UNITED STATES PATENT AND TRADEMARK OFFICE

APPLICATION NO.	FILING DATE	FIRST NAMED INVENTOR	ATTORNEY DOCKET NO.	CONFIRMATION NO.
10/620,282	07/14/2003	James D. Pylant	067810/0303800 PI-015	7725

Office Action Summary	Application No. 10/620,282	Applicant(s) PYLANT ET AL.	
	Examiner Jack W. Lavinder	Art Unit 3677

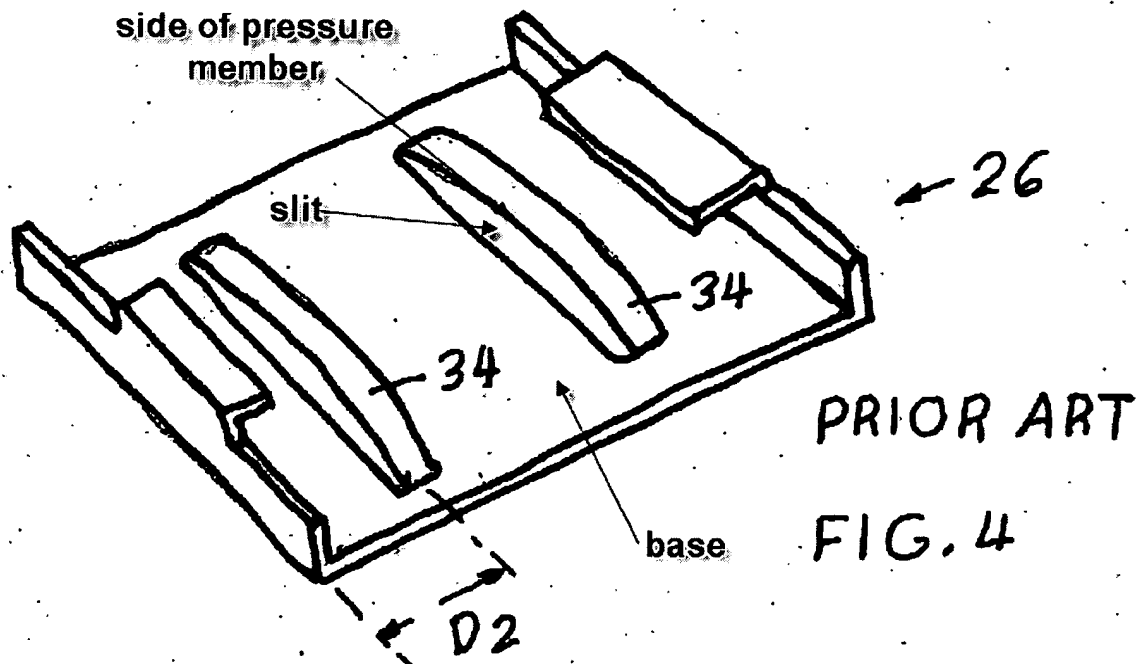
The applicant states that the prior art clip (figure 4 of applicant's specification) fails to teach a slit between the base and the side of a pressure member as recited in claims 1 and 16.

Figure 4 of applicant's specification clearly discloses a slit between the side and the base...see illustration below:

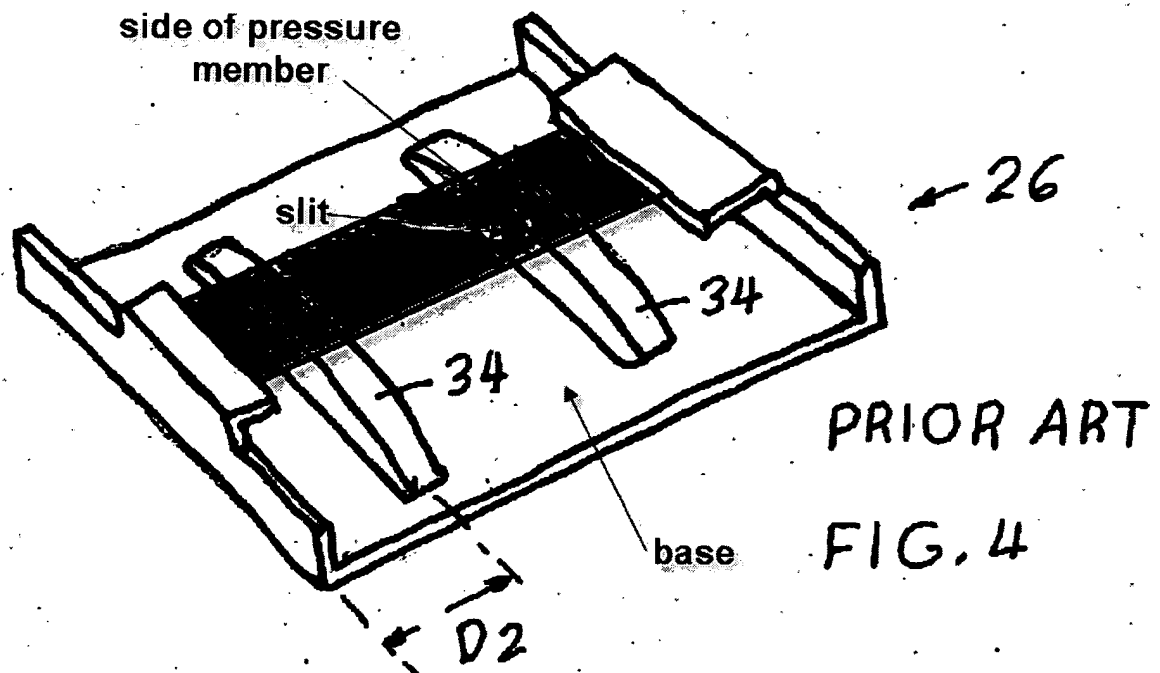
The applicant also states that the prior art device applies pressure to the center of the workpiece. This is true, but the limitations in the claim are only functional limitations. The only requirement needed to meet functional limitations in a claim is that the prior art device be capable of performing the functional limitations. In this instance, the springs (34) can apply a force "on a portion of the perimeter of the stack", i.e., if the stack is a narrow stack...see enhanced illustration of the prior art shown in figure 4 of applicant's specification.

The darkened rectangular could be a stack, wherein the pressure members (34) apply a force to a portion of the perimeter of the stack.
